**Before the Hearings Panel  
At Porirua City Council**

**In the matter of** the Proposed Porirua District Plan

**Reply on Hearing Stream 5 of Rose Armstrong, Landscape Architect, on behalf  
of Porirua City Council**

# Appendix 1 - Reply to Hearing Stream 5 of Rose Armstrong -IGL.

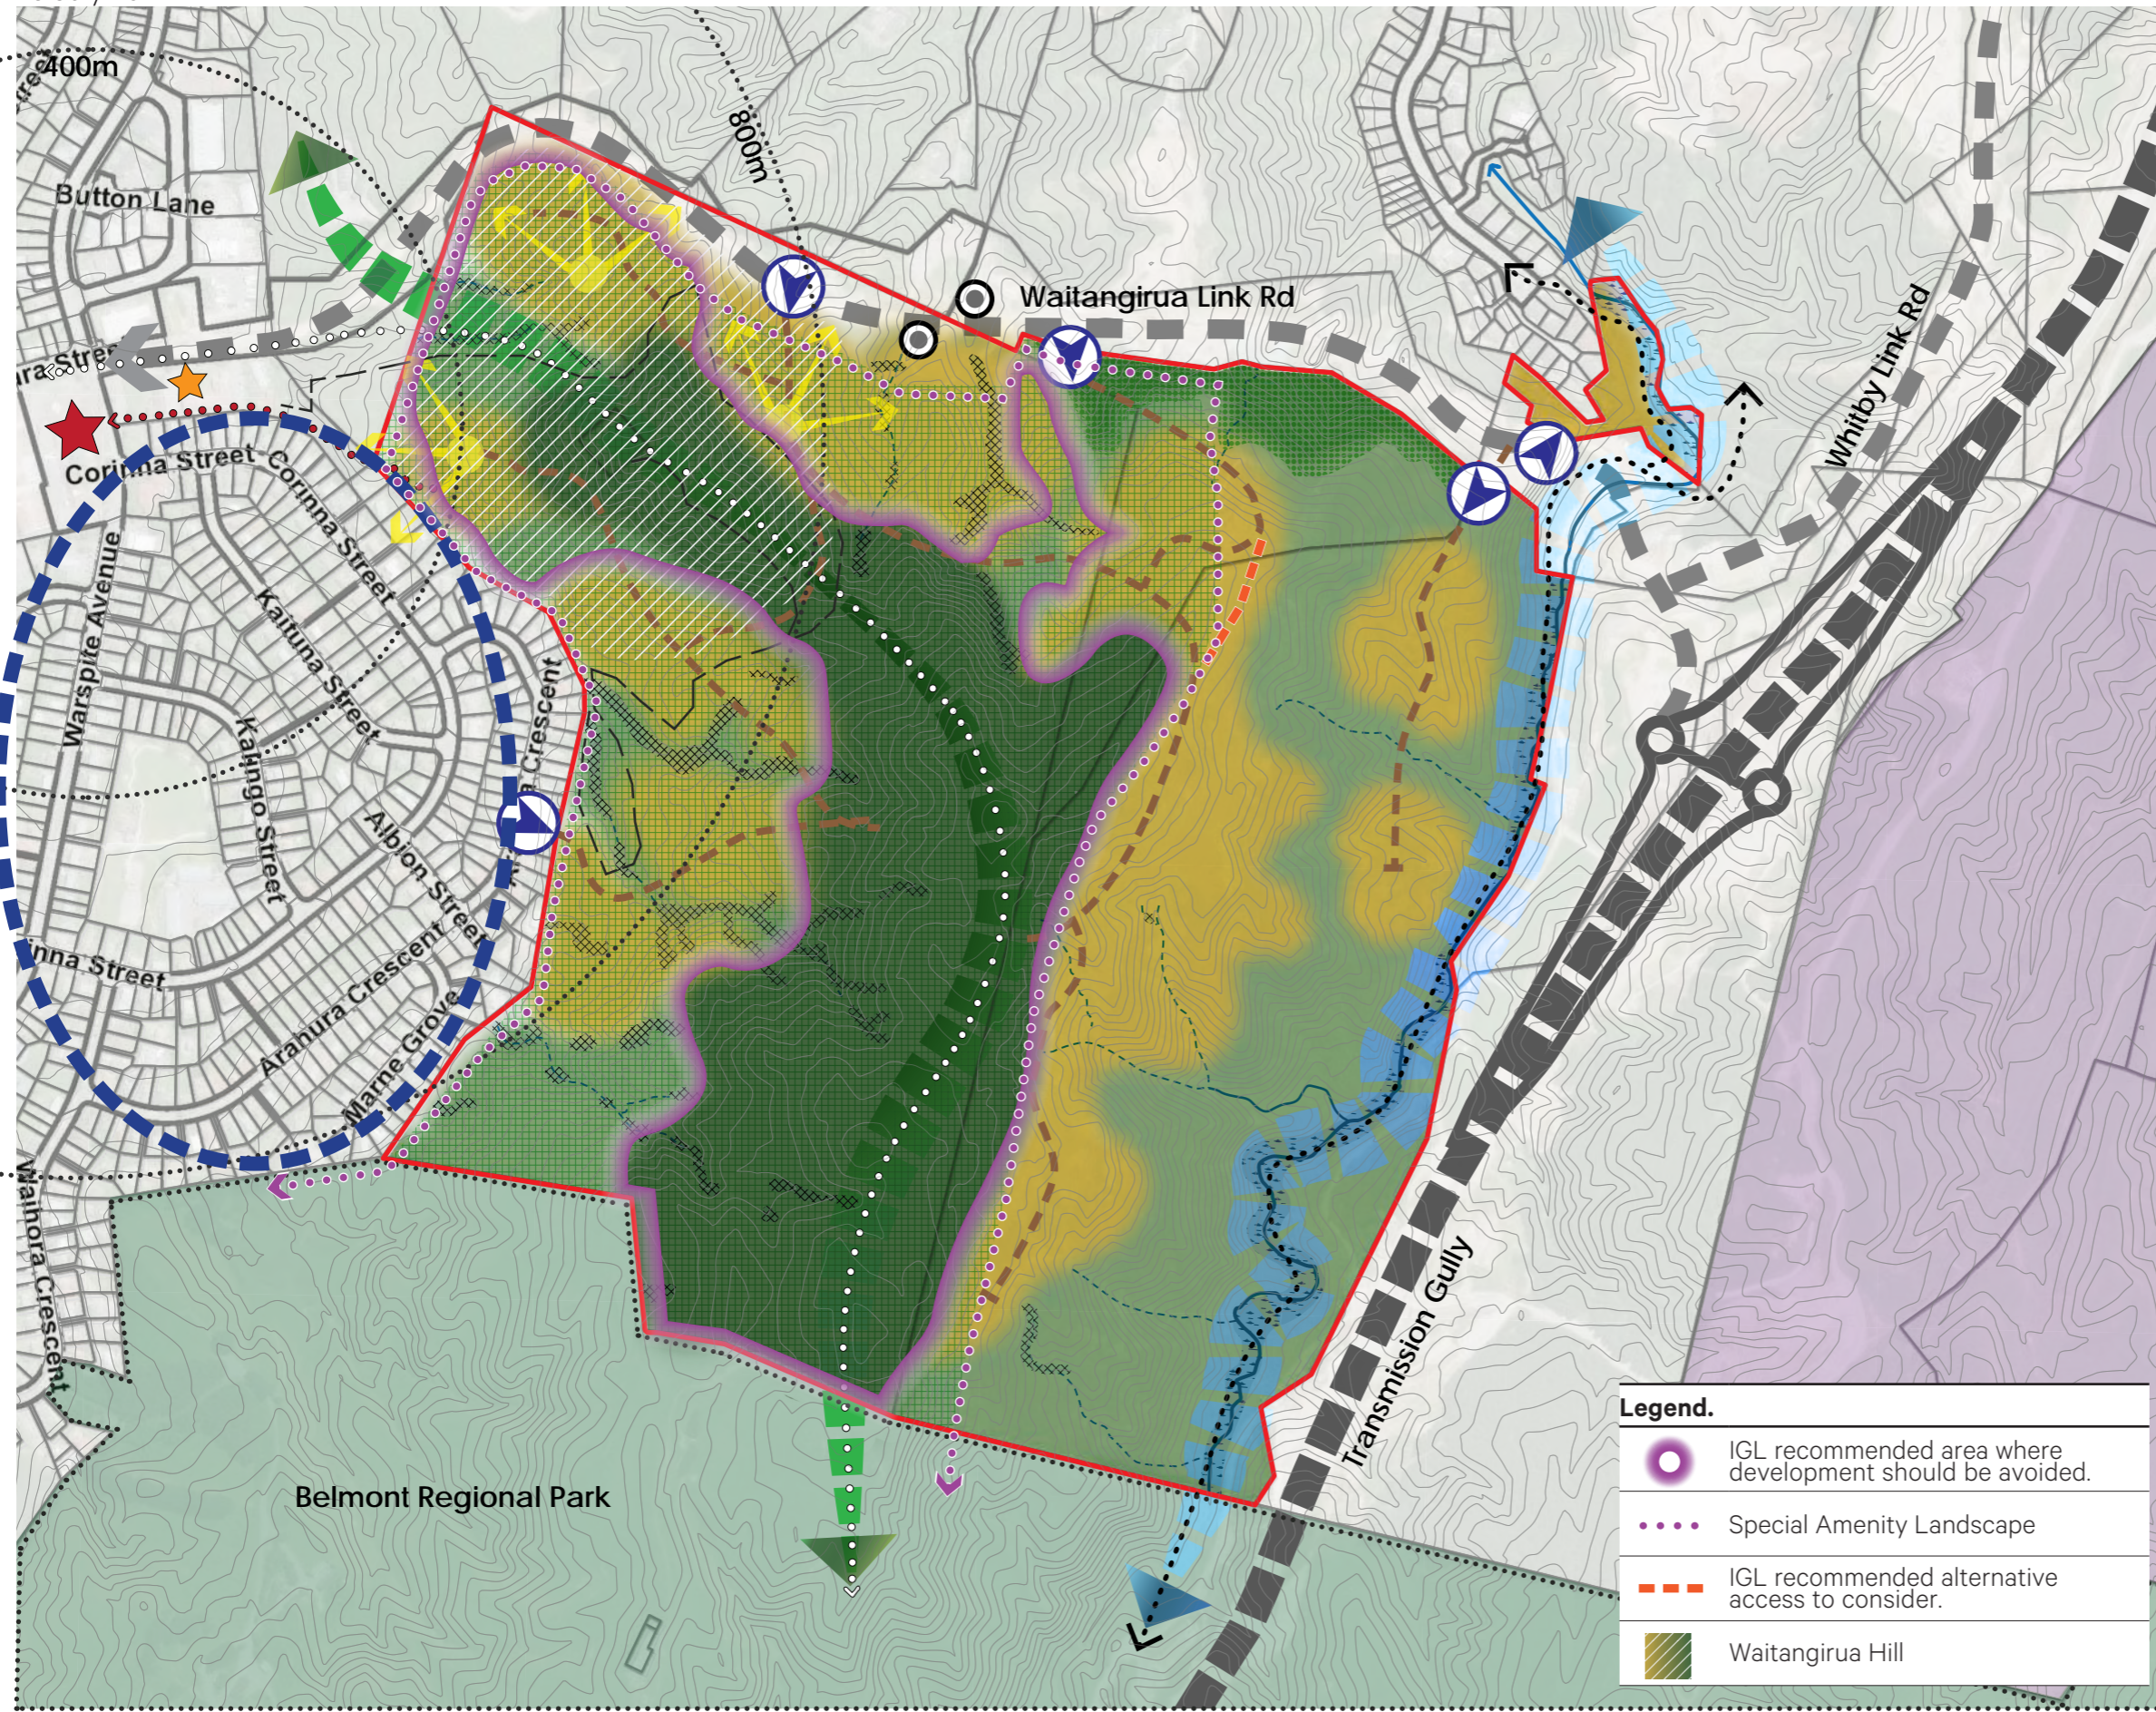
13 I have attached a broad-scale map as Appendix 1, showing those parts of the SAL I consider should be avoided in development of the site, to maintain SAL values.<sup>5</sup> In summary, these parts include much of the

Waitangirua Hill<sup>6</sup> landform, (particularly west-facing slopes above Waitangirua), the main ridge through the SAL (with associated hilltop slopes below the ridgeline), and an area of very steep and complex topography above the Waitangirua Link Road to/from the Transmission Gully motorway.

- 14 The draft Structure Plan includes development across the Waitangirua Hill landform except at the knoll/trig area and immediately adjacent (lower) slopes. In my opinion, this level of development on the Hill would be likely to adversely impact identified Sensory and Shared and Recognised values of the SAL relating to the distinct and recognisable landscape “marker” the Hill/landform provides (being visually distinct from adjacent developed areas).

- 15 The proposed roading in the Draft Structure Plan (where it crosses the main ridgeline, and where it traverses the steep and complex topography in the northern parts of the SAL above the Waitangirua Link Road), could also, in my opinion, put SAL values at risk – by extending earthworks and development into these visually prominent and sensitive parts of the SAL, including at the skyline (on the main ridge, in some views<sup>7</sup>).

- 17 With regards to the middle access road proposed in the draft Structure Plan off the Waitangirua Link Road, it may be possible to alter the route to locate the road to the east of the main spur in this area. This would avoid the very steep and complex topography which sits above the link road and is highly visible from the road, on leaving the district.<sup>10</sup> Roading in this area would likely require substantial earthworks, and these could adversely impact SAL values. (An amended route for investigation is suggested in Appendix 1 to this Reply).

- 16 If roading across the main ridge is unavoidable for development of the site,<sup>8</sup> its design would (in my opinion) need to use an appropriate

alignment and width to reduce earthworks including low cut and fill heights, avoid highly visible infrastructure components (such as lighting), and predominantly conceal the roading with vegetation, (integrated into planting in adjacent wider areas), in order to maintain SAL values.<sup>9</sup>
